ECE/TRANS/WP.15/2008/5
15 February 2008

PROPOSALS FOR AMENDMENTS TO ANNEXES A AND B OF ADR

Section 9.2.2.5, 9.7.8 and 8.3.8: Explosion protection

Transmitted by the Government of Germany ^{*/}

Example for consequences: Road tanker for Class 3 with vapour recovery

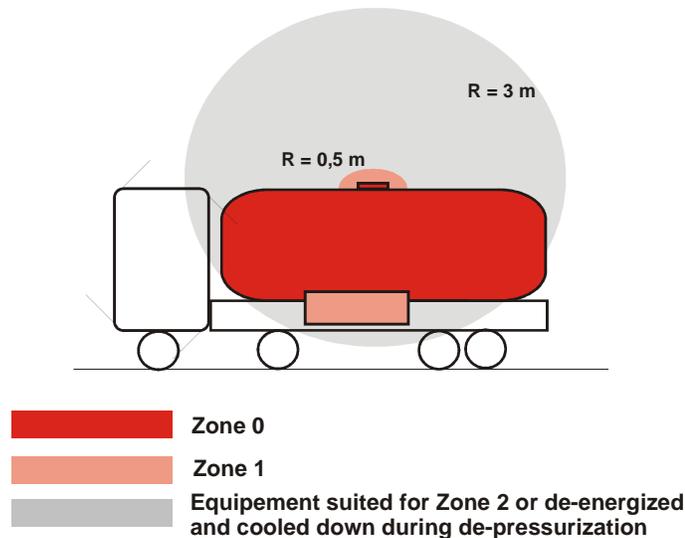
9. It is supposed that no automatically acting venting device is provided. De-pressurization of the tank is carried out by opening the dome hole cover – this has to be done before filling in order to introduce the loading arm with integrated vapour recovery line. The vapour recovery is performed by fitting the arm gas tight to the dome hole. This type of vehicle is typically used for chemicals in Germany. The following figure indicates for the attributed zones the respective areas where operational requirements shall be imposed according to the results of the research project:

Zone 0: Inside tank compartments, fittings for filling and discharge and vapour recovery lines (same as ADR).

Zone 1: Inside cabinets for equipment used for filling and discharge and within 0.5 m from the dome hole cover.

In a sphere with radius of 3 m around the dome hole electrical as well as non-electrical equipment which is not in a Zone, the equipment

- shall comply with the requirements for use in Zone 2 or
- shall during de-pressurization of the tank be de-energized or switched-off or cooled down to avoid ignition by hot surfaces.
